SEWAGE DISPOSAL SYSTEM

DEPARTMENT OF HEALTH AND MENTAL HYGIENE

SUBDIVISION Ashleigh Knolls LOT 120 ROAD 7128 Crabbury Court

Re: Permit Number B00106062
Ashleigh Knolls, Lot 120

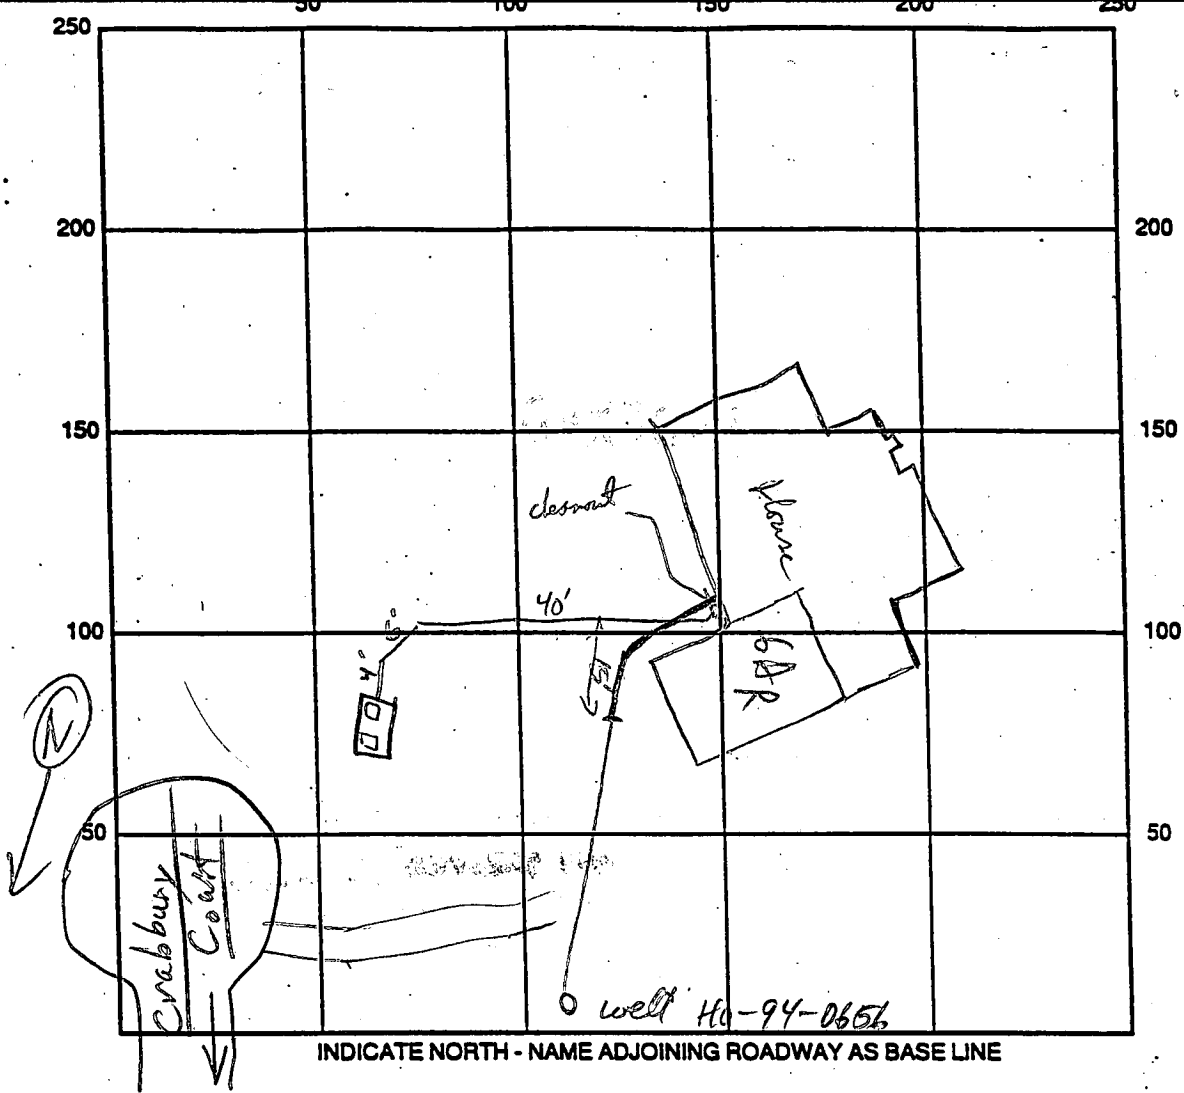
Need to finish grade or
Raise well casing to 8" above grade. *10/16/97*
P 58495-B

Need to sleeve water line where down then 10' to sewer line - Sleeved to 15 ft from base line OK 10/6/97
WPT - p/10m adapter OK 10/6/97 3 1/2 ft R/P 10/6/97 - well casing is only 2" above current
grade - Need to raise well casing to at least 8" above pad/broke - Still needed 10/7/97 R/P well casing OK
 DATE SYSTEM APPROVED br 12/11/97 INSPECTOR [Signature] 1 Final grading 12/11/97 R/P

REMARKS: Septic line OK thru house connection - out to cover R/P 10/6/97
call for Pump Test. Pump Test OK 12/11/97 R/P

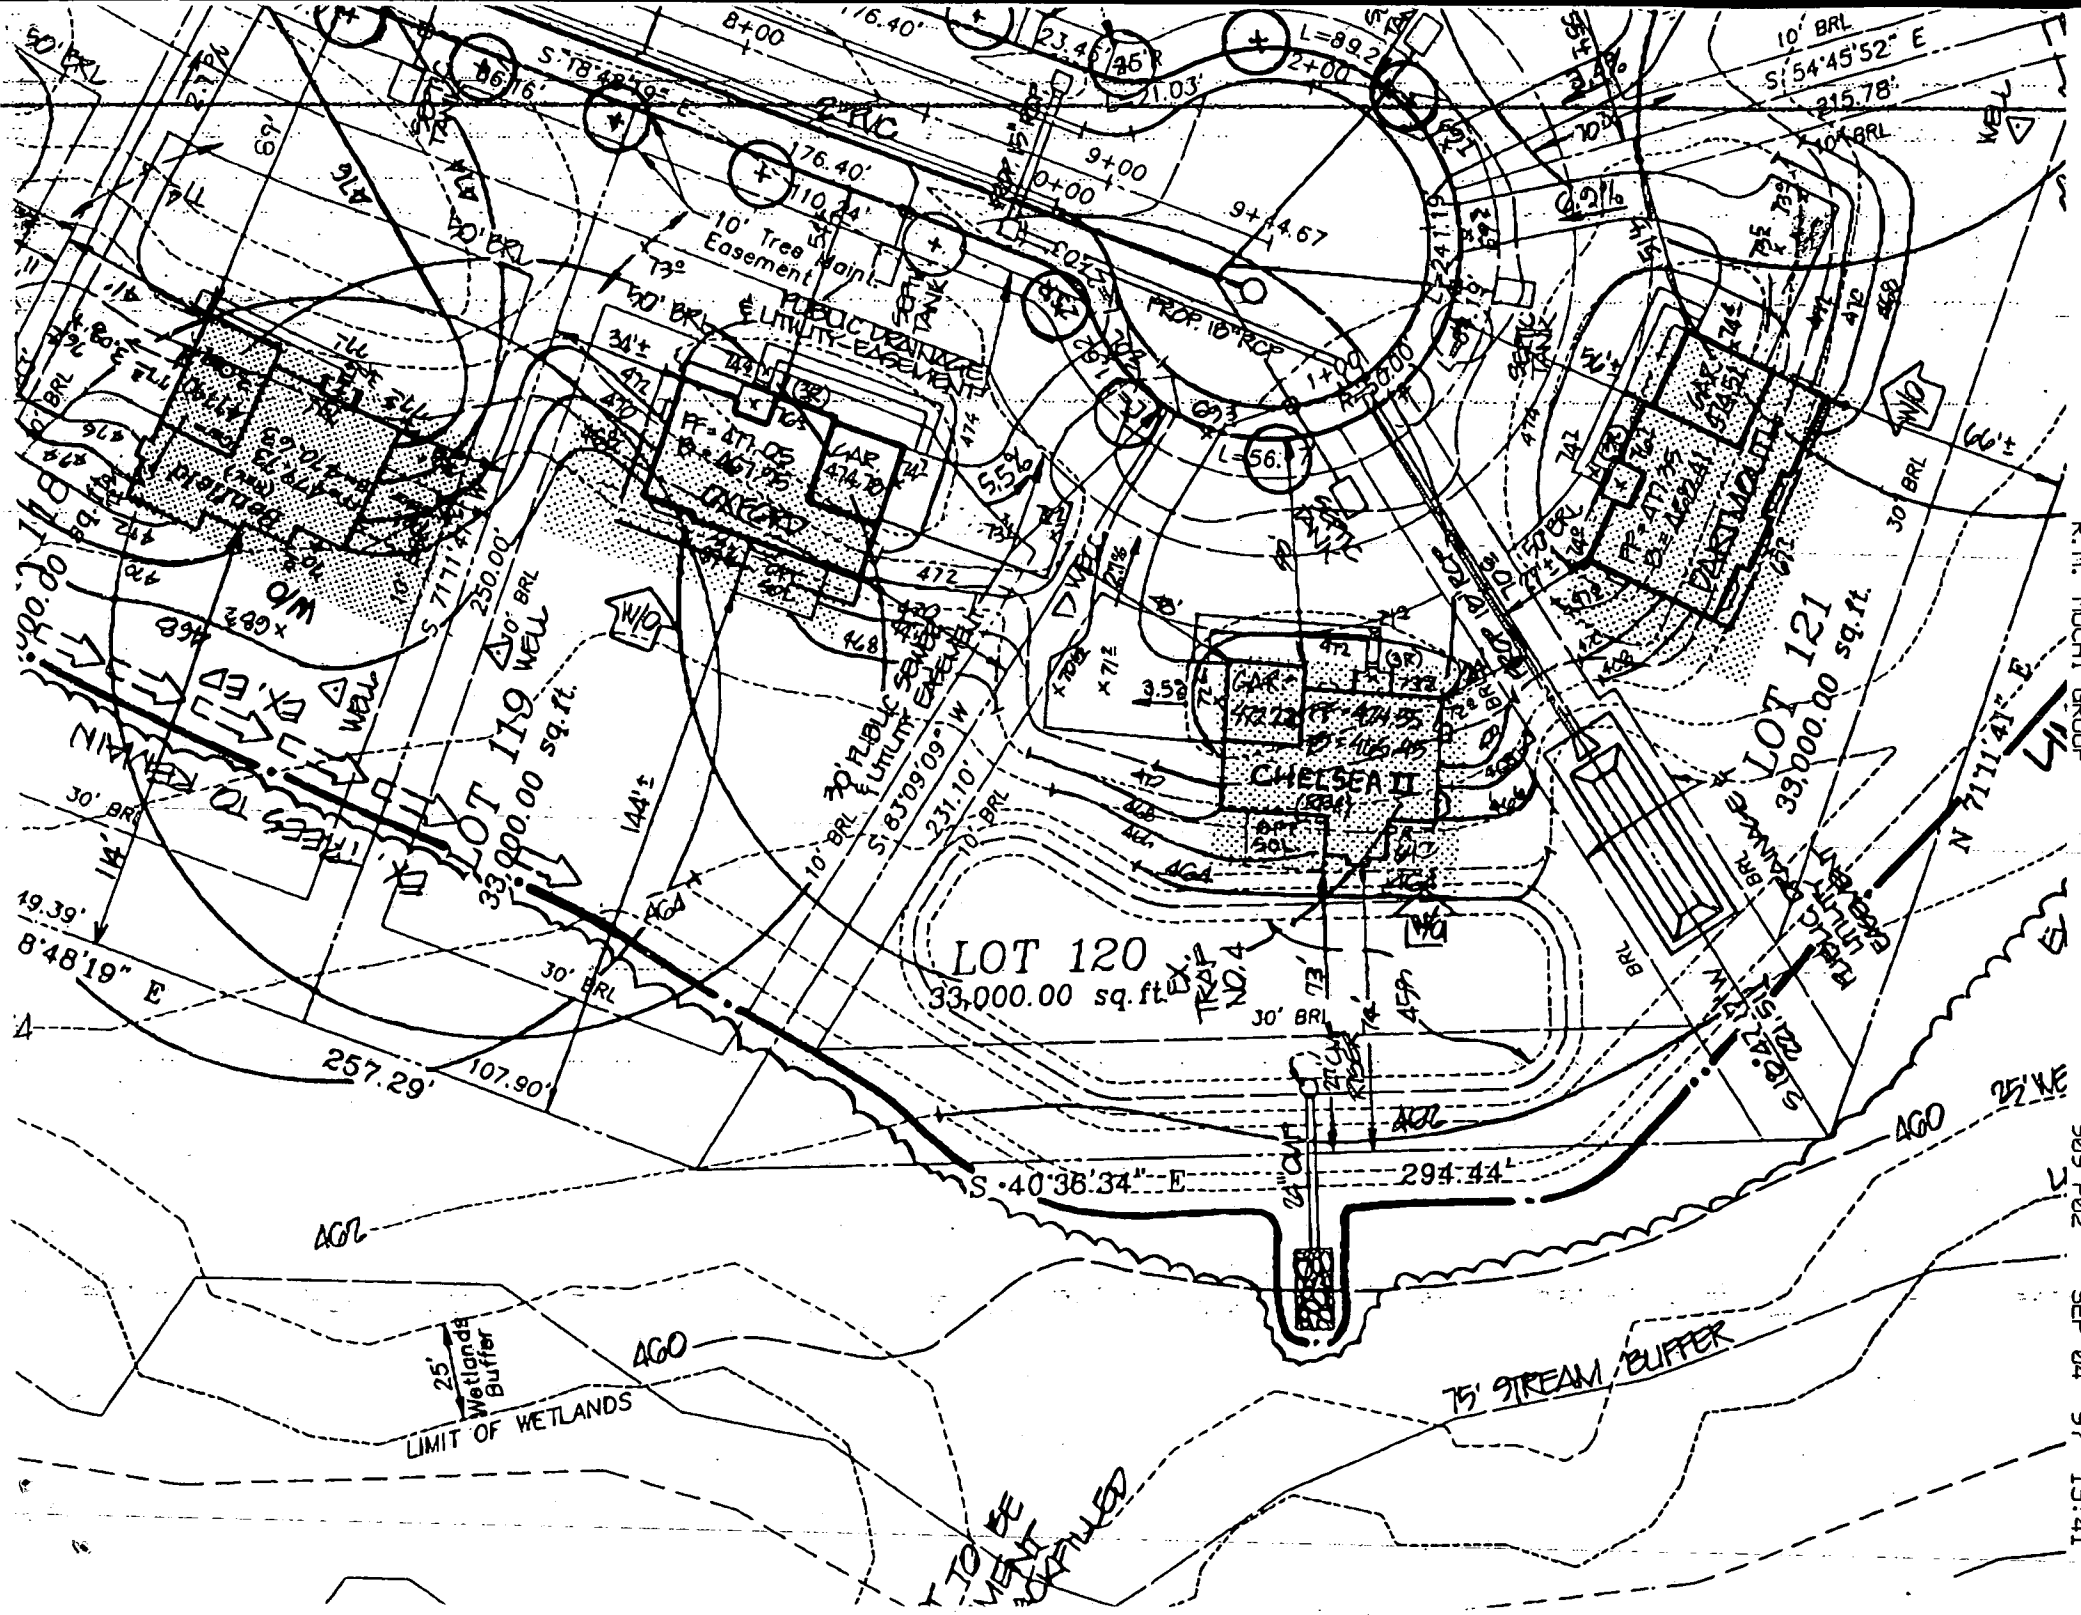
Winchester Homes, Inc. would like to revise the above permit by changing the house type from a Browning to a Chelsea II. The Chelsea II will also have a finished basement with a full bath and a rear solarium.

9/5/97 Revision OK - no impact to well or septic.
SAS

Re: Permit Number B00106062
Ashleigh Knolls, Lot 120

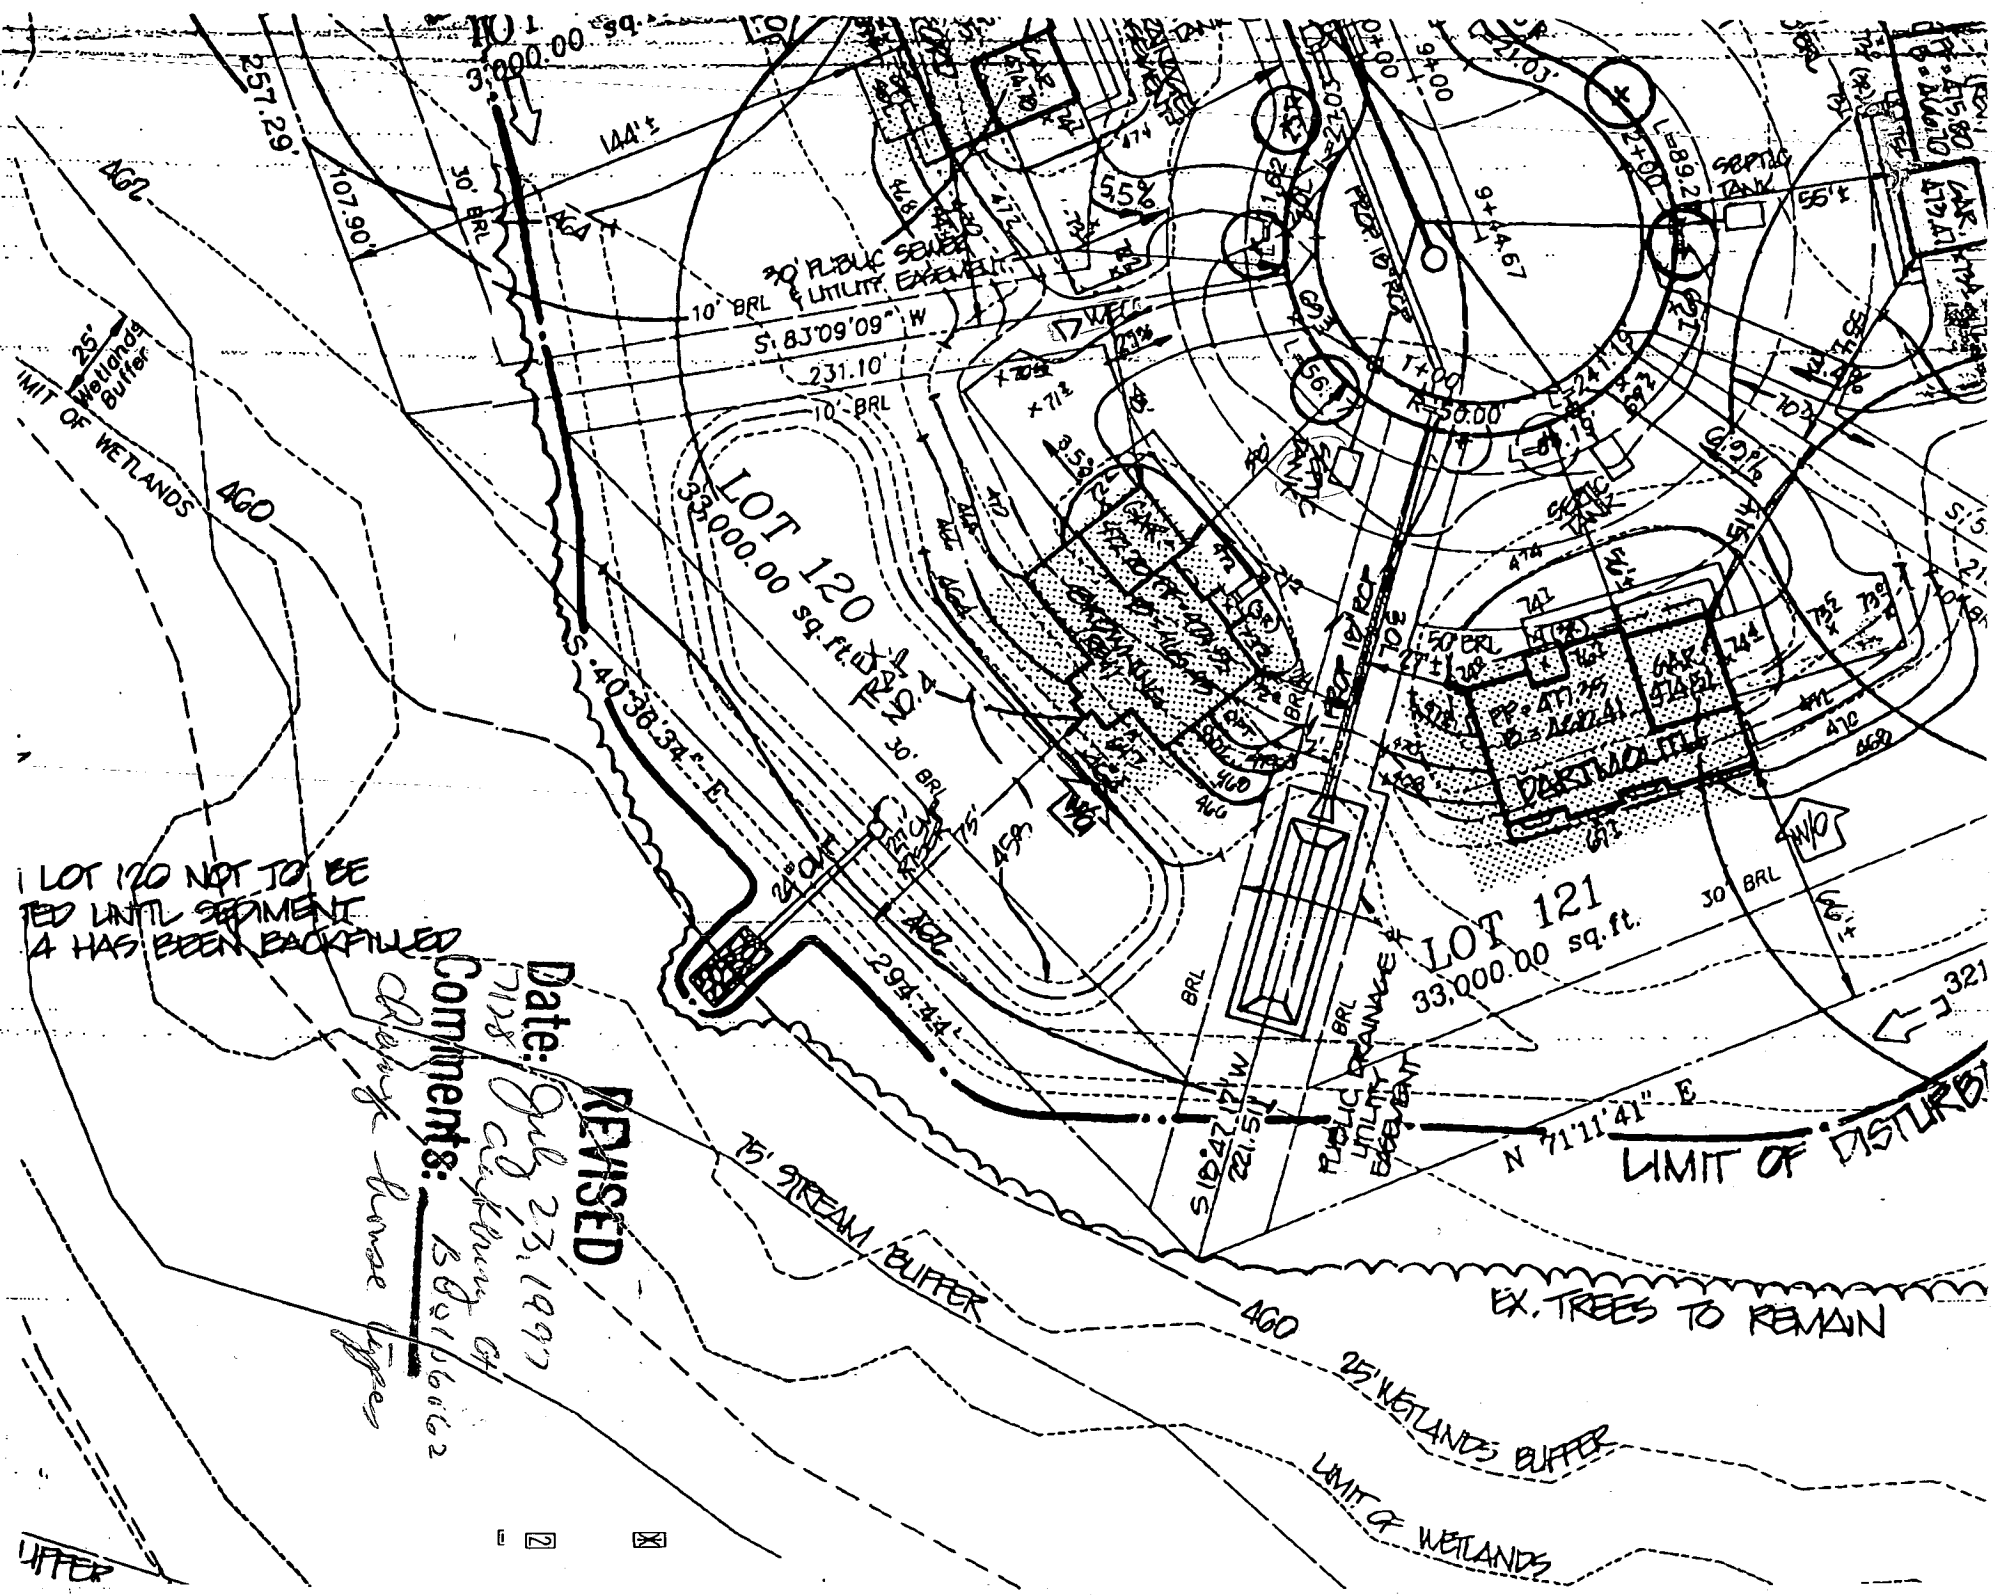
Winchester Homes, Inc. would like to revise the above permit by changing the house type from a Dartmouth to a Browning. The Browning will also have a finished basement with a full bath and a side solarium.

7/23/97
Revision ok - no
impact to well
or septic (DKS)
